Parker House

## 5.0 Aldwych Workshop

Following confirmation from UKPN that the electrical substation is no longer required, this NMA seeks to substitute the space previously designated for the substation, as the community room. Relocating the community room from the first floor to ground allows for wheelchair access, which previously did not. Furthermore, the proposal returns the first floor terrace to its existing, open form, maintaining the characteristics of the townscape.

- 1.1 Point 2 Surveyors have been instructed to consider the daylight and sunlight effects of the Parker House redevelopment in respect of the proposed Non Material Amendments (NMA) to the consented scheme. This Addendum Statement follows on from the Daylight & Sunlight Report prepared by GVA Schatunowski Brooks dated November 2012 (The GVA Report).
- 1.2 The purpose of this Addendum Statement is to assess if the NMA will lead to any additional impact to the daylight and sunlight amenity enjoyed by existing neighbouring dwellings beyond that reported in the GVA Report. Consideration has also been given to the daylight quality within the new habitable rooms.

### 5.01 Aldwych Workshops Plan

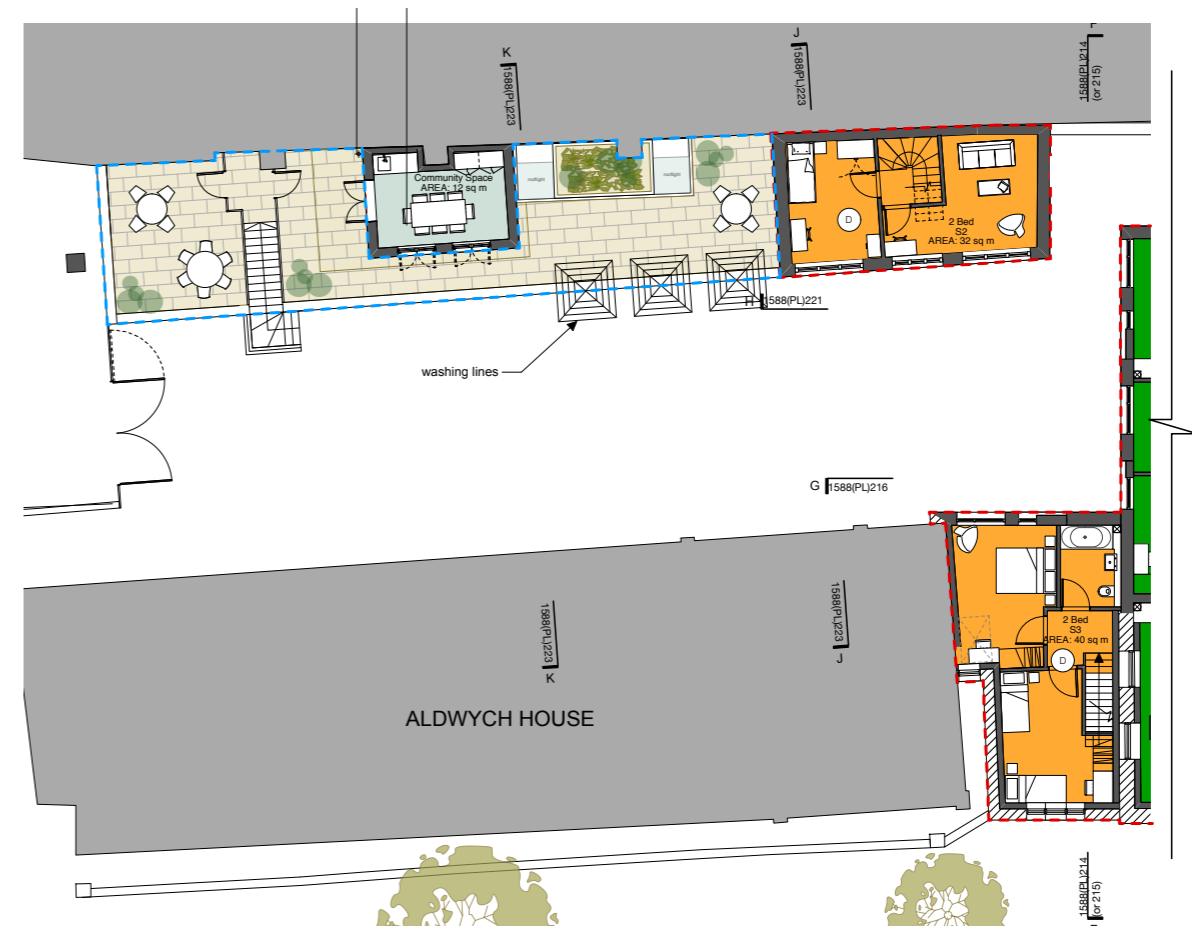
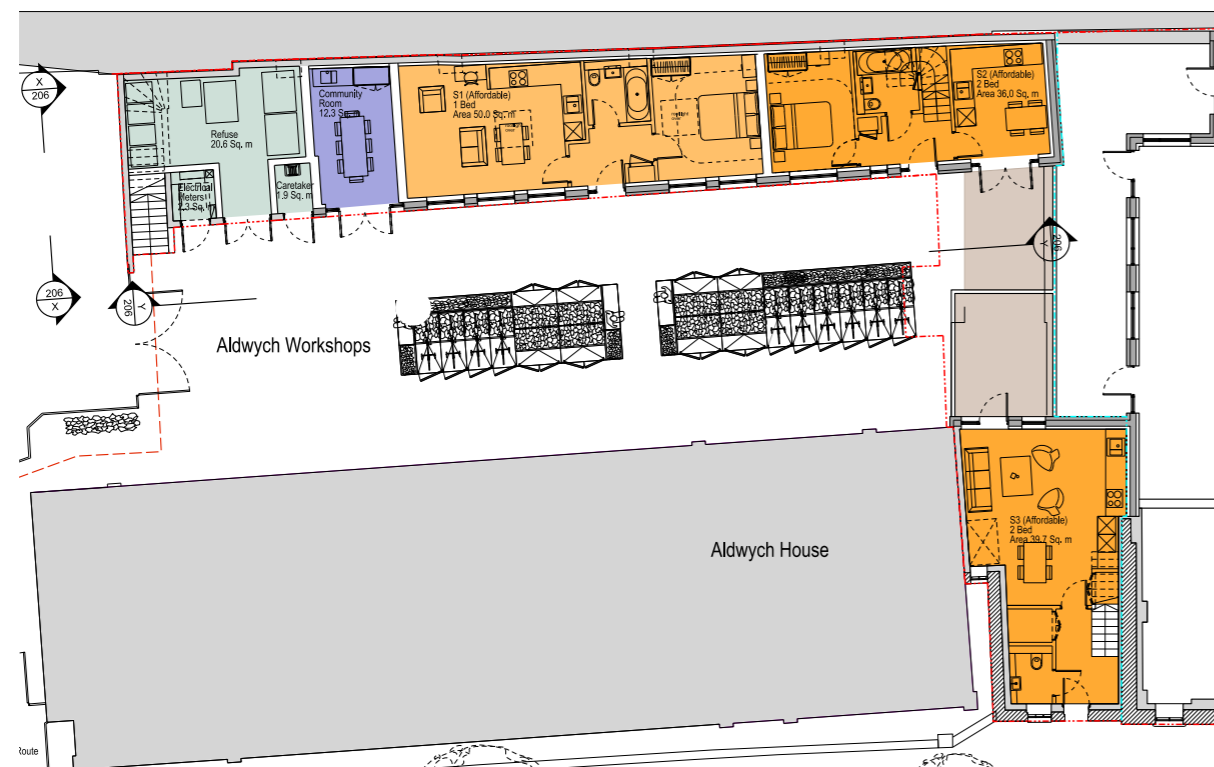
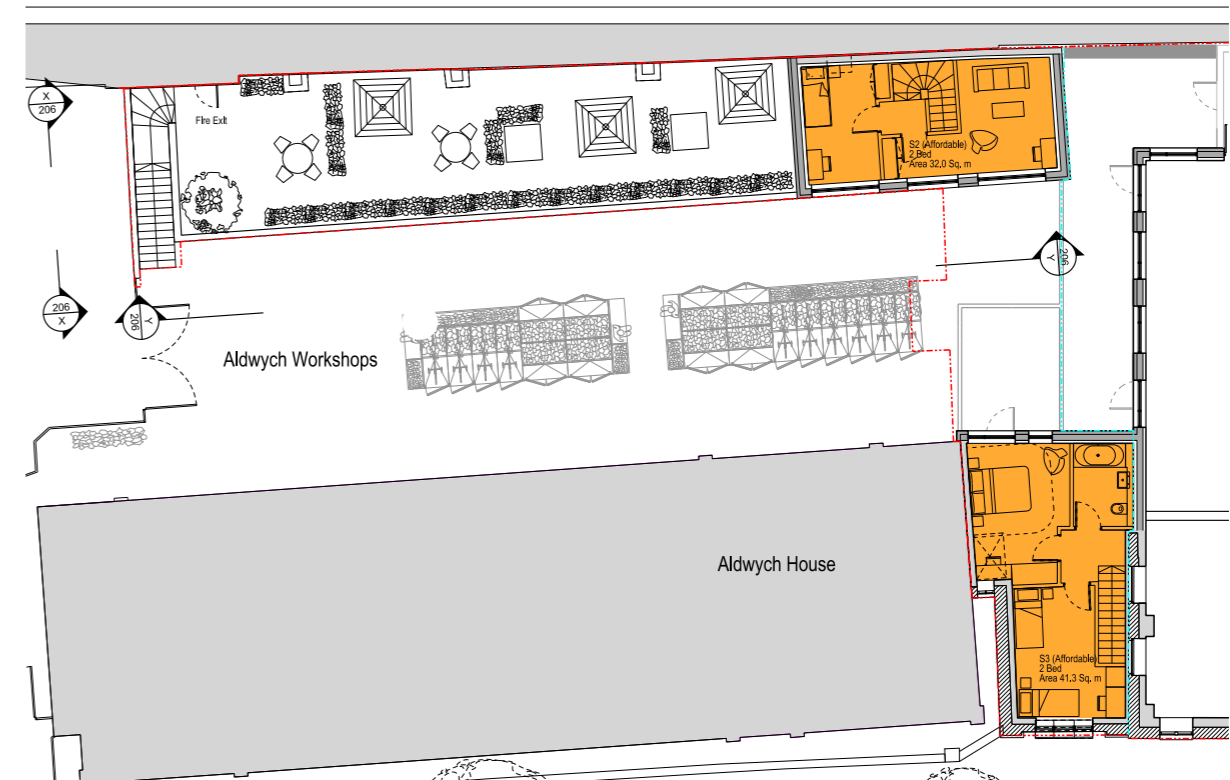
Stairs which serves as access to communal terrace space and fire escape for 10-14 Macklin St. building have been maintained, however, reallocated and amended to be compliant with current building regulations.

Whilst altering certain elements of the building, the residential units remain unchanged from previous consent.
